Service Letter No. 431

SUBJECT: Insulation of Motor Mounts

AIRCRAFT AFFECTED: PA-24 "250" Comanches - Serial Nos. 24-3558 to 24-3687
incl. also those Comanches listed in note of this service
letter

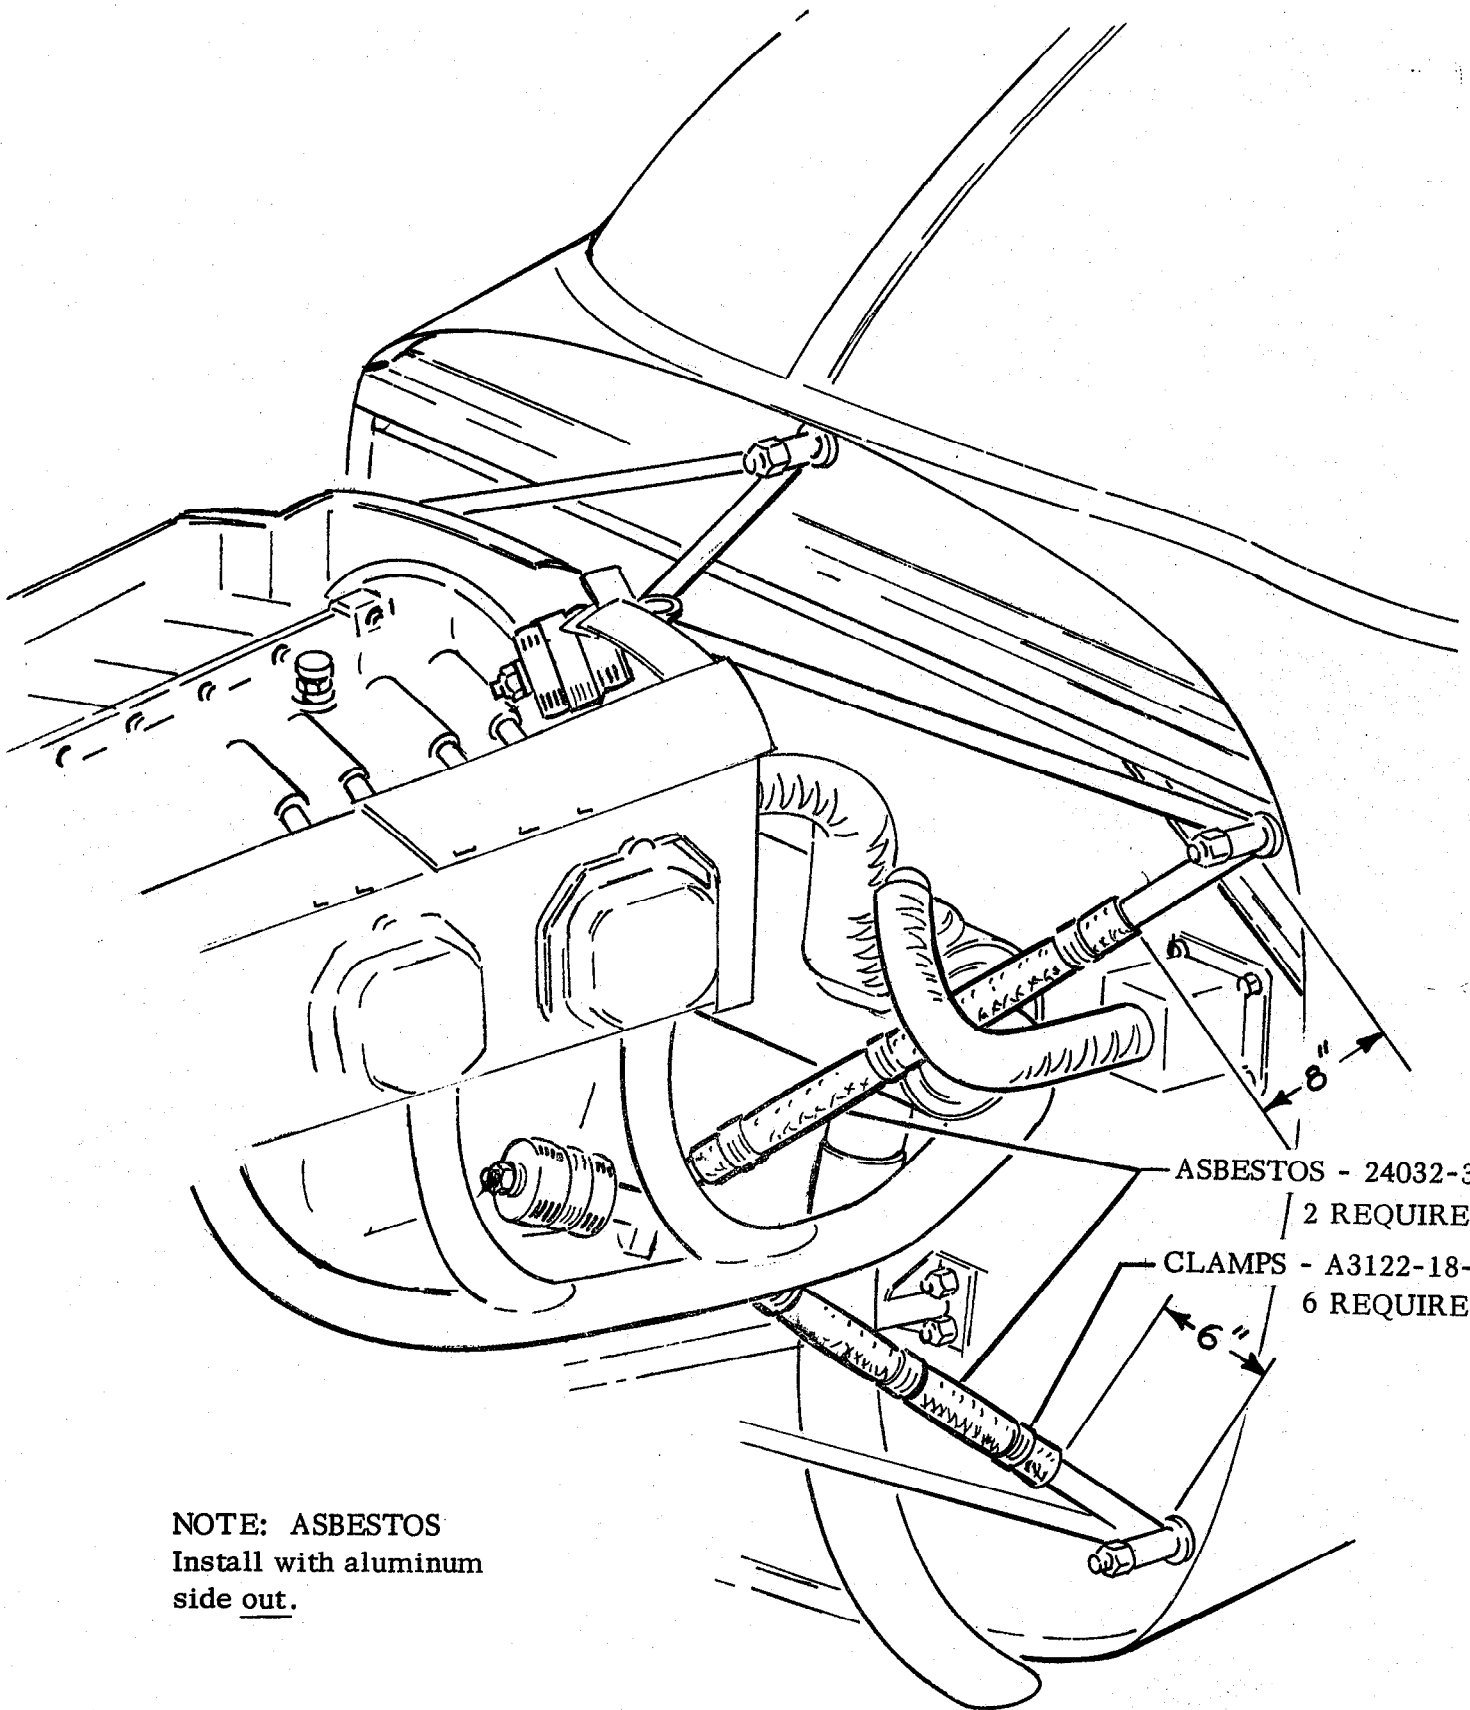
The aircraft indicated by the above serial numbers are equipped with a hollow type muffler. Service reports from the field indicate that, due to the construction of this hollow muffler, the engine mount tubes have shown evidence of heat at the end where the burned gases enter the tailpipe. This heat has resulted in two of the engine mount tubes becoming scorched and, in some cases, a slight amount of corrosion has been noted.

In order to protect these tubes, kit number 756 831, consisting of two (2) asbestos blankets and clamps, is available for installation and it is required that it be installed. See sketch on reverse side of this service letter.

Prior to the installation of kit number 756 831, the tubes should be cleaned to the bare metal and if pits are noted, they should be sanded until the metal surface is free of paint and pits. When necessary to remove pits by sanding, the tubes should not be sanded beyond a depth of .005 on either side. When the tube is cleaned of paint and any corrosion, the tube should then be painted; first with prime (either zinc chromate or red oxide) and then with two coats of any lacquer or enamel.

ASBESTOS - 24032-35
2 REQUIRED
CLAMPS - A3122-18-1
6 REQUIRED

NOTE: ASBESTOS
Install with aluminum
side out.
